HARTING Product Change Notification

Business Unit: HARTING Electric GmbH & Co. KG
Product range: Han® M
Author: Jürgen Bösch
Title: Han® M Hoods and Housings

PCN/0032
 Date: 20140331

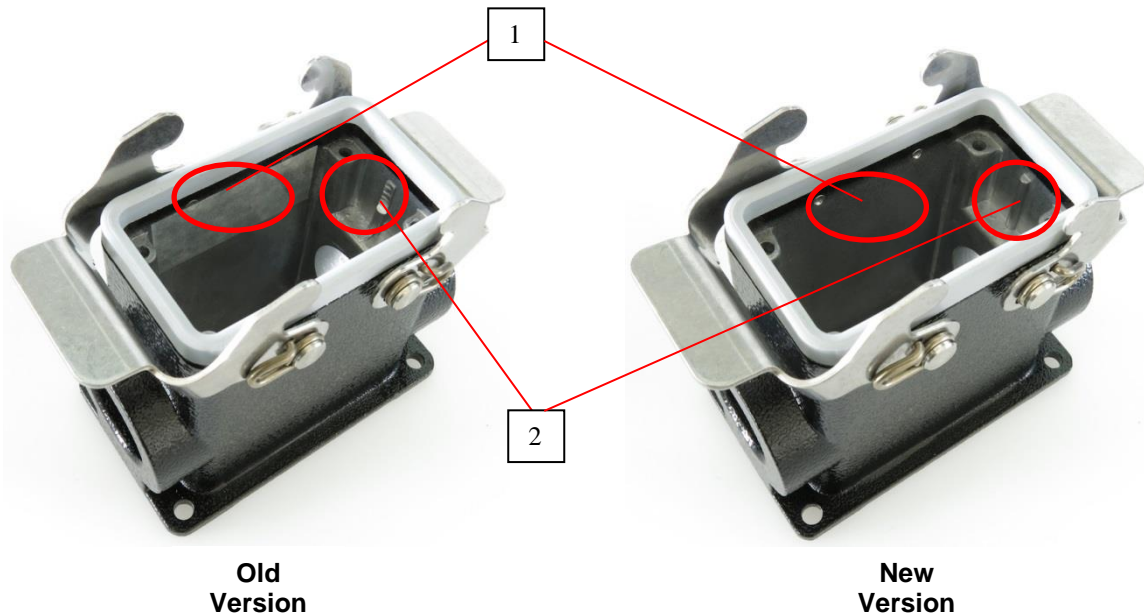
Han® M hoods and housings size 10B, 16B and 24B will be delivered without the insulation tapes at each long side (1) and without removed ribs at the short sides (2) in the future.
